IV. Comments on the Appendices, Tables and Figures

RMC Comments to EA/IS July 20, 2009 Page 44 of 48

Report on the Effects of San Joaquin River Interim Restoration Flows on Shallow Groundwater Within CCID

Map of Shallow Observation Wells within 3 miles of the San Joaquin River Red Highlighted Wells indicated locations impacted by Interim Flows

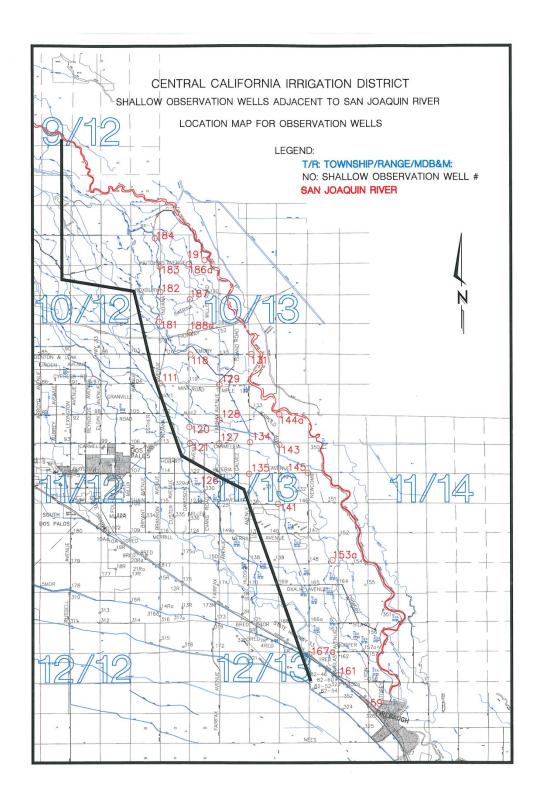
CCID has maintained and monitored shallow groundwater observation wells within its service area since 1983. The District has typically measure depth to groundwater, and taken water samples to measure both Electroconductivity (EC) and Boron. The following is a base map showing the location of the CCID shallow observation wells within the CCID boundaries and within 3 miles of the San Joaquin River northwest of the City of Firebaugh.

Graph 1 shows hydrographs for Wells 126, 134, and 118 and the hydrograph of the average depth to groundwater of the wells of present concern.

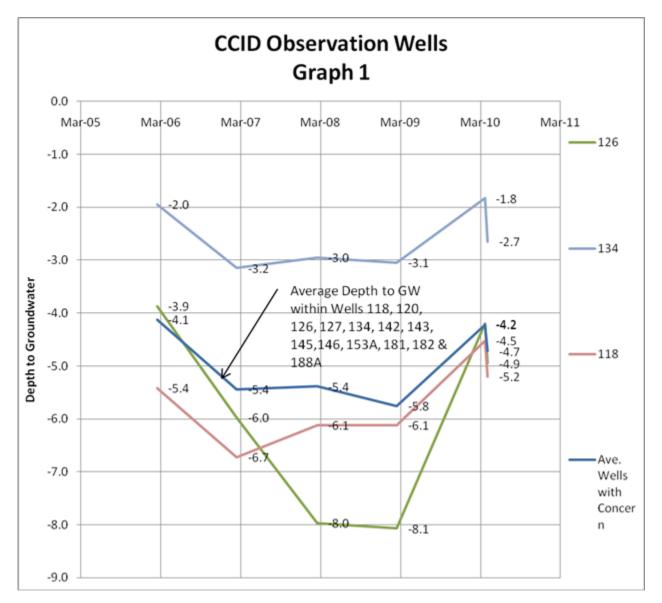
The chart shows that the interim flows have caused shallow groundwater in these areas to the levels from of March of 2006 when the river was in extreme flood stage (4500 cfs from Pine Flat Reservoir).
